**#2010-51**

**Chase Bank – 1185 S. Route 31 Lutter Center  
Project Review for Planning and Zoning Commission**

**Meeting Dates:** September 1, 2010 and September 15, 2010

**Location:** 1185 South Route 31 (Lutter Center)

**PROPOSED SITE PLAN**  
 June 29th, 2010

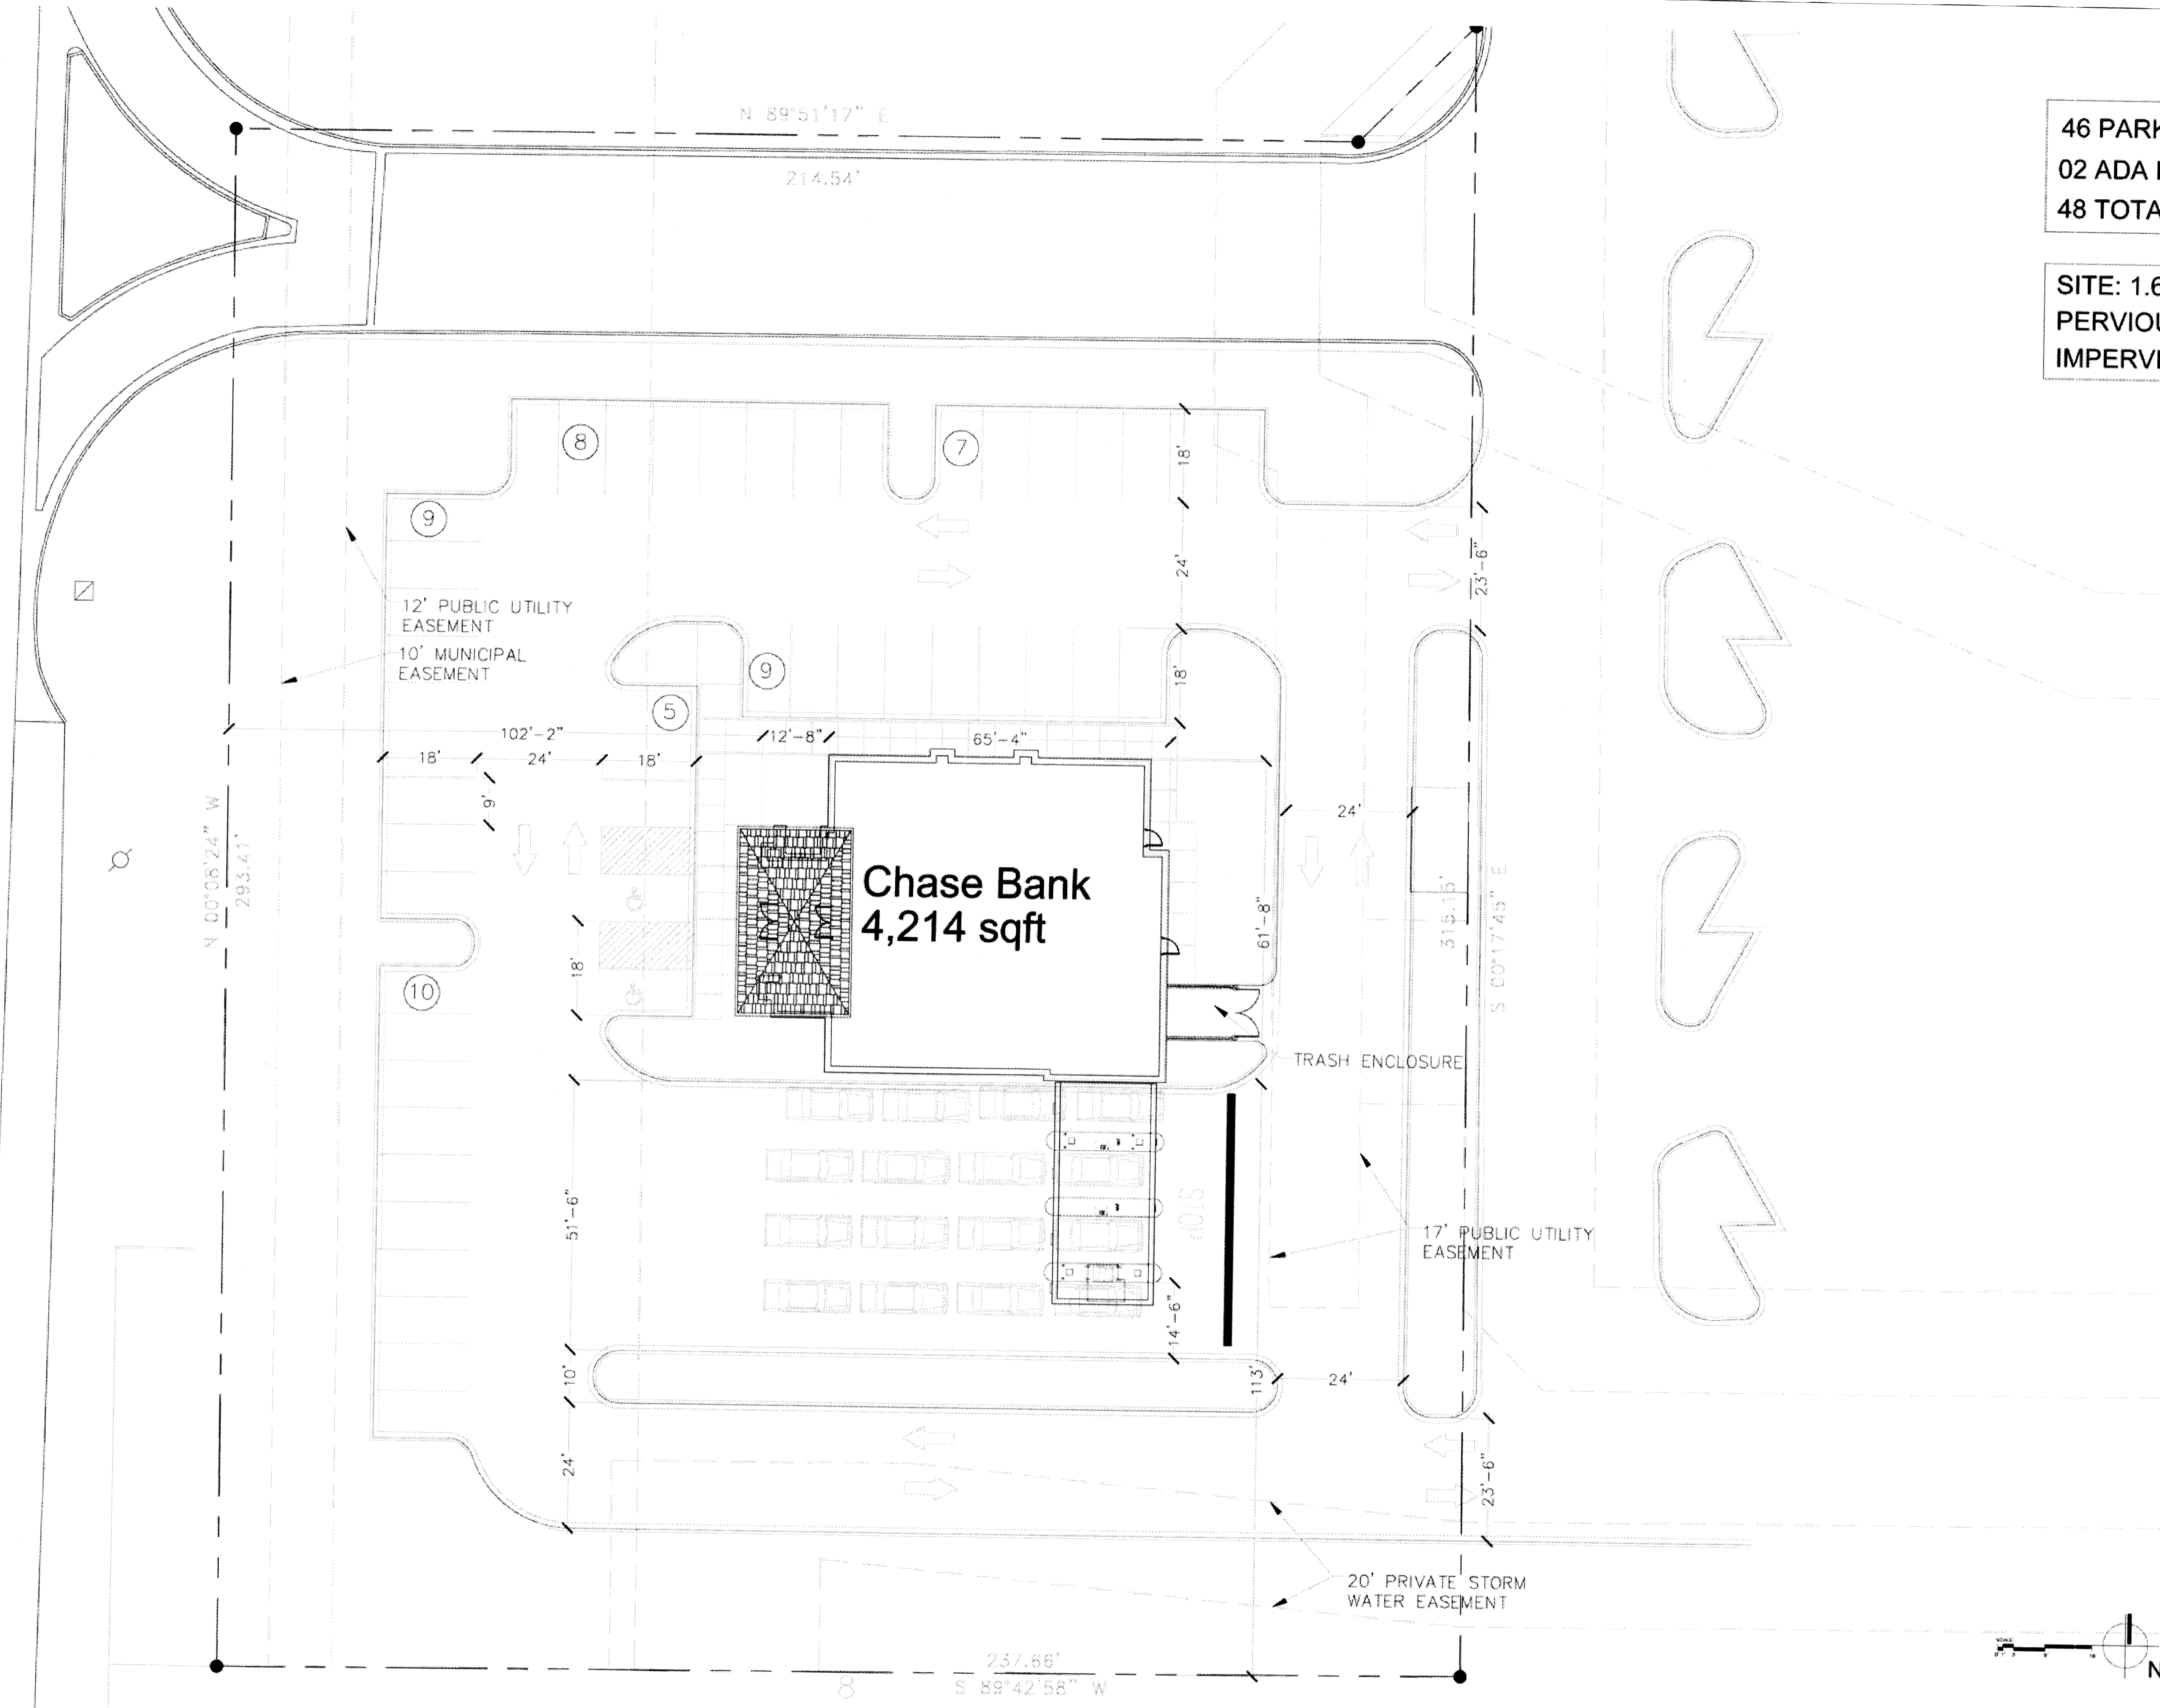
The new branch building would be placed within the center of the lot. Access to the site will be from the existing frontage road from Central Park Drive or the adjacent right-in/right-out drive from Route 31. Full two-way access is provided around the site including a bypass lane around the drive-through lanes. The front of the bank will face Route 31. The drive-through is located on the south side of the bank which will be visible from Route 31. There are 3 drive-through lanes and 1 drive-through ATM lane.

The site is providing 48 parking spaces located on the north and west sides of the building. Financial Institutions with a drive-through are required to provide 1 parking space per 350 gross square feet of building space. At 4,214 the Chase Bank is only required to provide 12 parking spaces. The UDO allows for parking lots to be oversized and any parking lot that provides over 125% of the required parking should do so with pervious materials. Thirty-three of the parking spaces should be of pervious material, which could include pervious asphalt or interlocking pervious paver blocks with gaps filled with fine gravel. The overall impervious coverage is 59%; 65% impervious is permitted. The reduction in the parking area would allow the engineer to better design for water management BMP's.

The petitioner is asking for two variations in conjunction with their PUD request. The first is to allow the parking to exceed 125% of the required parking and not utilize impervious materials. This variation goes against the ideals of a PUD which require creative and imaginative design. Staff would require that data be provided to the City illustrating the total number of employees on shift and number of customers per hour to support a higher parking need. Staff can then reevaluate the parking and any parking exceeding the 125% shall be constructed of pervious materials.

2. The requested parking variation shall be eliminated:
  - A. Chase Bank shall provide additional data on the total number of employees on shift and customers per hour that support a higher parking requirement.

- B. Any parking provided above the 125% required shall be constructed of pervious materials.

3. Site Plan
  - A. The site plan shall be amended per Wal-Mart's driveway requirement and Engineering's comments. This shall shift the driveway further south away from the right-in/right-out access from Route 31 and increase the opening radius.

**1 Landscape Plan**  
SCALE: 1" = 20'

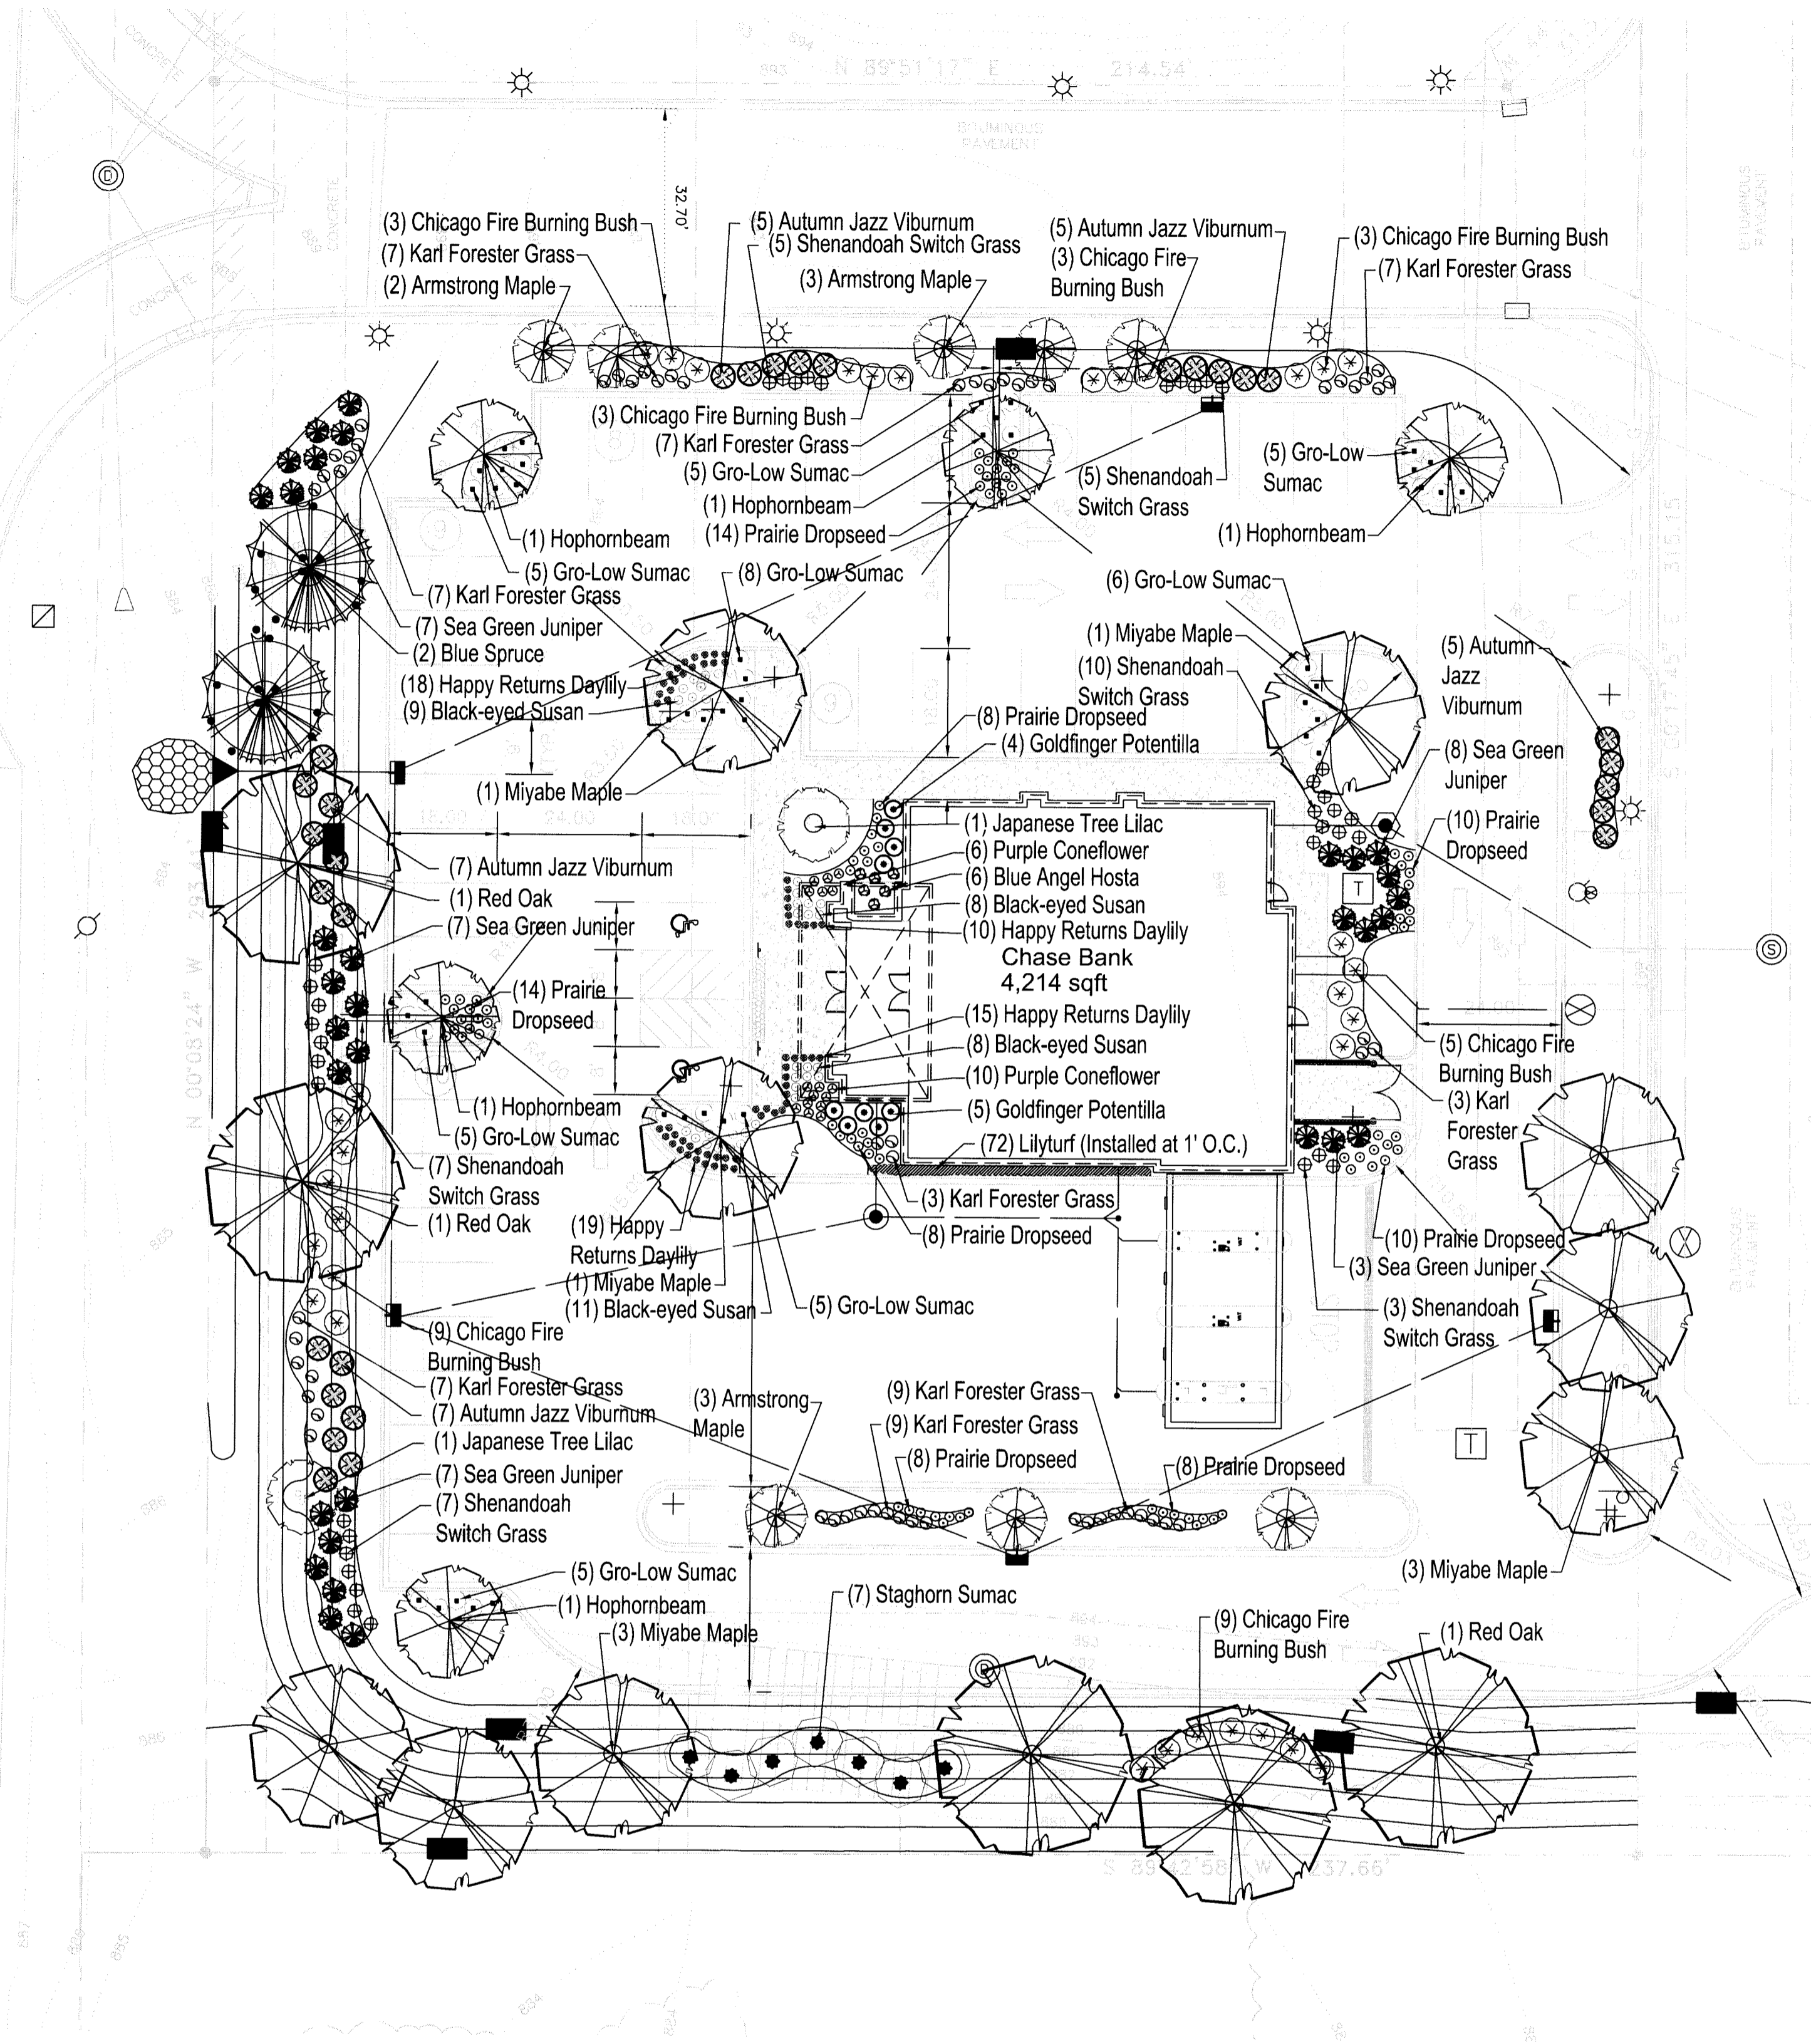
The site has landscape planned for the perimeter within the berm around the west and south sides and the islands on the north and east sides. Foundation base landscape would be a variety of small ground shrubs and flowers. The trash enclosure and transformer are located in the rear of the building and will be screened with deciduous and evergreen plants. The site is located within the Village of Cary's groundwater recharge area. The site will need to be designed with BMP's. These BMP's shall be incorporated within the proposed landscape or handled mechanically.
